DRAGON VALVES, INC.

Reference: Arizona Public Service Co.
Palo Verde Nuclear Generating Station
Bechtel Power Corp. Deficiency Evaluation Report No. 82-48
Dragon Valves Excess Flow Check Valves

Subject: Final Report - DER 82-48
A 50.55(e) Reportable Condition Relating to
Dragon Valve Company Instrument Line Check Valves
Seized Open by Welding Heat
File: 32-019-026
D.4.33.2

FINAL REPORT - DER 82-48
DEFICIENCY EVALUATION 50.55(e)
ARIZONA PUBLIC SERVICE COMPANY (APS)
PVNGS UNIT 1

REVISIONS		14388
LTR	DESCRIPTION	DATE
A	E.O. 81041	6-1-81
B	E.O. 81079	11-12-81
C	E.O. 82006	2-4-82
D	E.O. 82046	10-2-82

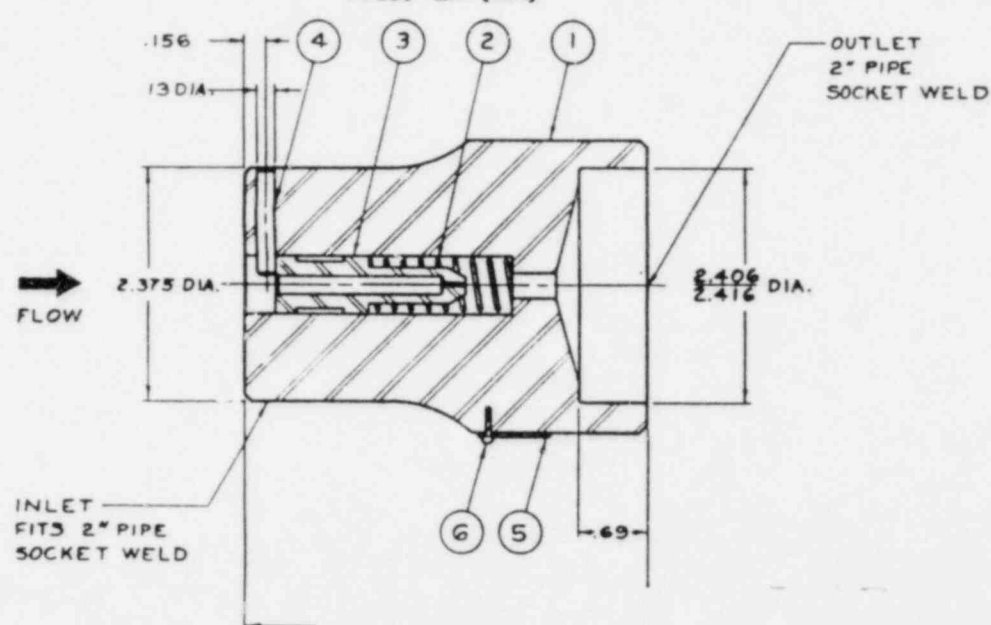
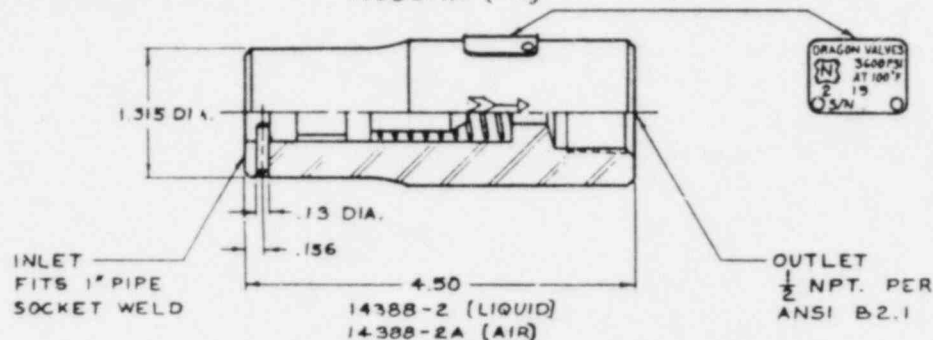
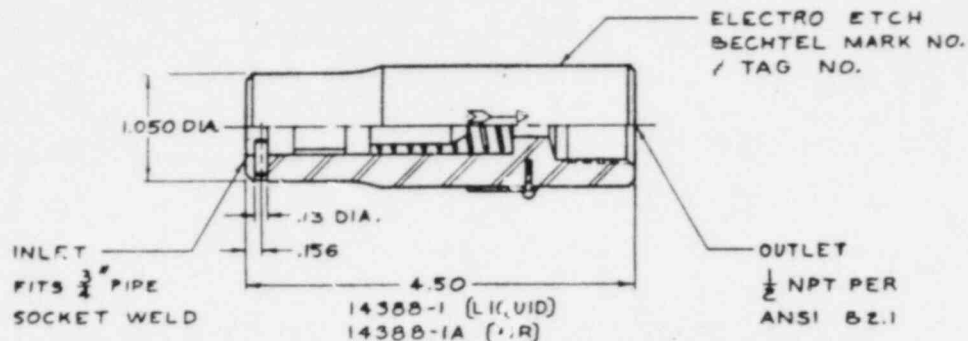
4B. The corrective action on the -1, -1A, -2 and -2A valves was accomplished by designing a new poppet configuration which would accomodate the I.D. bore dimension change without affecting the valve function. Sample modified poppets were sent to the site for Bechtel evaluation. The modified poppets were found to function after welding without further rework or modification. Modified poppets, enough for one power plant unit, were shipped to the site to be installed in valves for Unit 1. Units 2 and 3 valves will be returned to Dragon for installation of modified poppets. In both cases, a "M" was added to the part number to identify the valves with the modified poppet (i.e. 14388-1M).

4C. Dragon Valves' Drawing No. 14388, Revision D, the current revision, incorporating the modifications discussed above, is enclosed.

2. ■ DENOTES EXCESS FLOW CHECK VALVE REQUIRING WELD ADAPTER. WELD ADAPTER TO BE FIELD WELDED TO VALVE BY CUSTOMER.

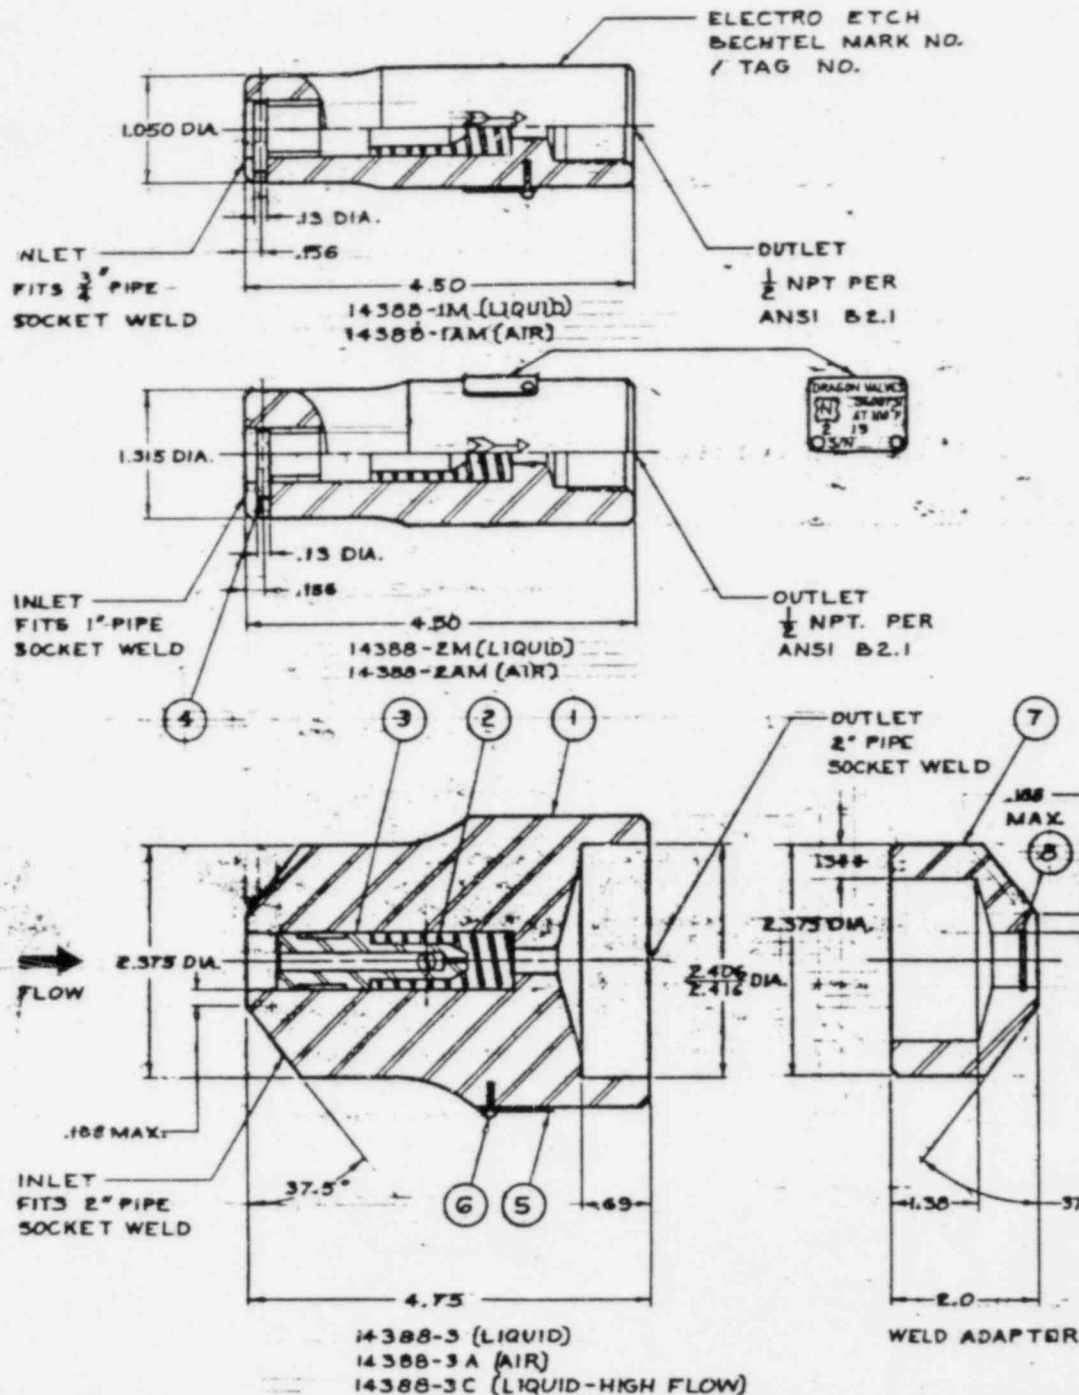
1. The subject Excess Flow Check Valves are Dragon Valves' Model Number 14388. Dragon Drawing No. 14388, Revision A, which describes the valves as originally shipped to the site, is enclosed. The subject valves are unique to Palo Verde Nuclear Plant.

2. The failure of the component is that, when welding the inlet connection, the poppet sticks in the open position. The I.D. bore in the body is reduced in the weld area and this localized deformation contacts the rear portion of the poppet. The deficiency was first identified on the -3 and -3A in January 1982 at the site by Bechtel site construction personnel. The -1, -1A, -2 and -2A deficiency was identified in June or July of 1982 by Bechtel site construction personnel.
